NL-04-0392

Edwin I. Hatch Nuclear Plant
Request for Additional Information on the Proposed Technical Specifications
Revision to Primary Containment Leakage Rate Testing Program

Request for Additional Information on the Proposed Technical Specifications Revision to Primary Containment Leakage Rate Testing Program

Figure 2
10 PSI NOMINAL OPERATING PRESSURE INCREASE

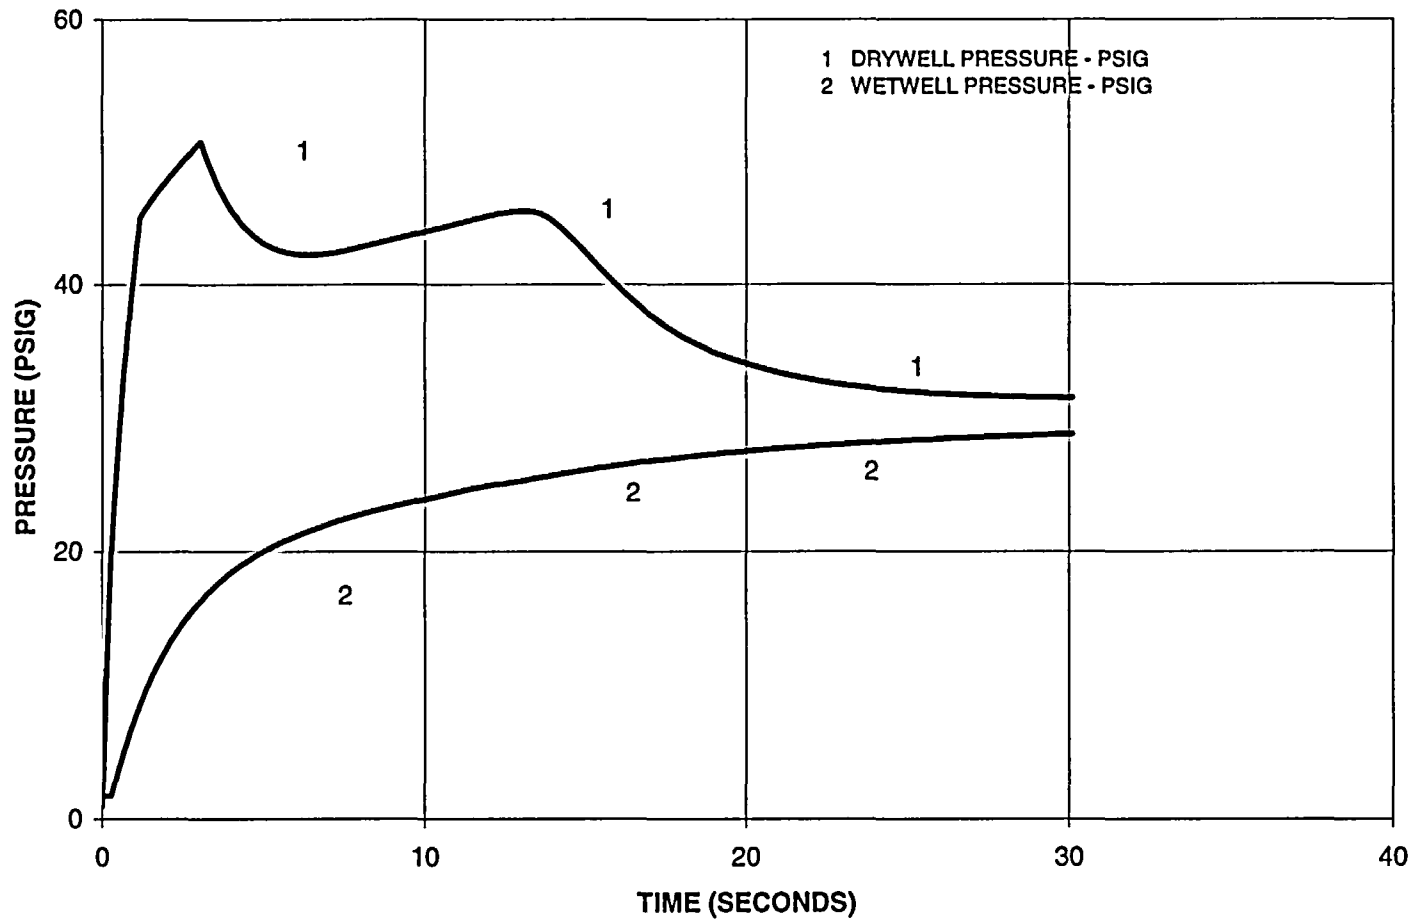
(2) Provide a comparison listing of the inputs for the new reactor steam dome nominal pressure to each input listed in the FSAR for the current licensing basis containment analyses (FSAR Table 6.2-6, "DBA-LOCA Initial Conditions, Assumptions, and Calculated Pressure Results"). Provide a comparison of the mass and energy releases and the pressure and temperature responses (current to revised pressure case), in graphical form, and include the suppression pool temperature response. (a) Will the FSAR be revised to reflect these new analyses? (b) If not, how will these analyses be maintained as "the current licensing basis containment analyses?"

The existing and revised time histories for various parameters (Pressure, Temperature, Mass and Enthalpy) are provided as a comparison in the following enclosed figures:

- Figures 1 and 8 Existing Unit 1 and Unit 2 Short-Term Containment Response Drywell/Wetwell Pressure vs. Time
- Figures 2 and 9 Revised Unit 1 and Unit 2 Short-Term Containment Response Drywell/Wetwell Pressure vs. Time
- Figures 3 and 10 Existing Unit 1 and Unit 2 Short-Term Containment Response Drywell/Wetwell Temperature vs. Time
- Figures 4 and 11 Revised Unit 1 and Unit 2 Short-Term Containment Response- Drywell/Wetwell Temperature vs. Time
- Figures 5 and 12 Existing Unit 1 and Unit 2 Short-Term Containment Response Break Flow vs. Time
- Figures 6 and 13 Revised Unit 1 and Unit 2 Short-Term Containment Response Break Flow vs. Time
- Figures 7 and 14 Unit 1 and Unit 2 Short-Term Containment Response – Energy Addition vs. Time
